MIL-V-2D  
 AMENDMENT 3  
18 February 1981  
 SUPERSEDING  
 AMENDMENT 2  
 10 August 1973

MILITARY SPECIFICATION

VALVES, CYLINDER, GAS

This amendment forms a part of Military Specification MIL-V-2D, dated 9 September 1970, and is mandatory for use by all Departments and Agencies of the Department of Defense.

FIGURE 1a. CAP AND PLUG

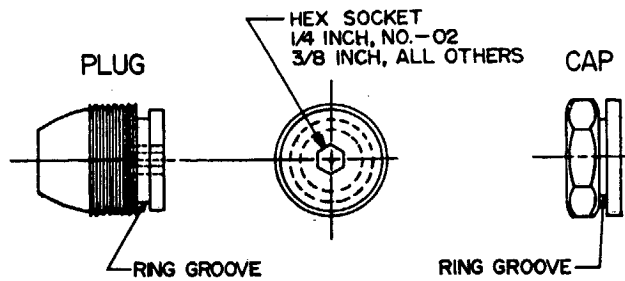
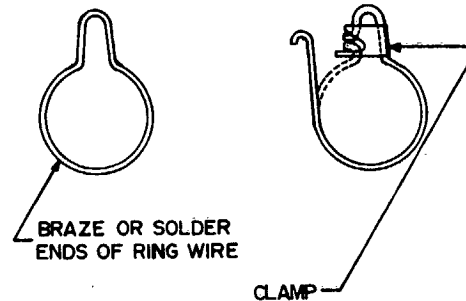
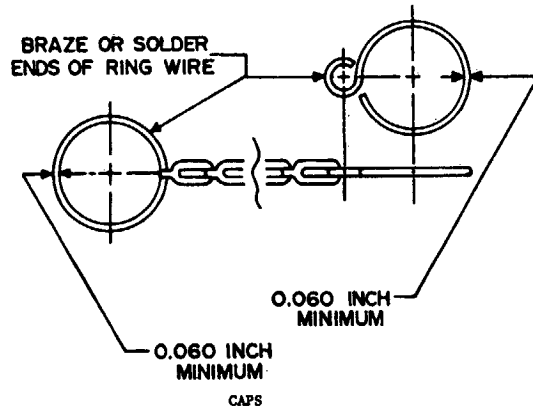
"3.9.8 Outlet cap and plug. When specified, valves with threaded outlets shall have a permanent metal mating plug or cap in accordance with figures 1a and 1 b. The metal plug or cap shall be supplied with retaining chain and clip to secure the plug or cap to the valve. The metal plug or cap shall effectively seal the valve against leakage when tested as specified herein."

3.9.8.1, line 8, delete period after "threads" and add: "in accordance with figures 1a and 1b."

Following page 42 add figures 1a and 1b.
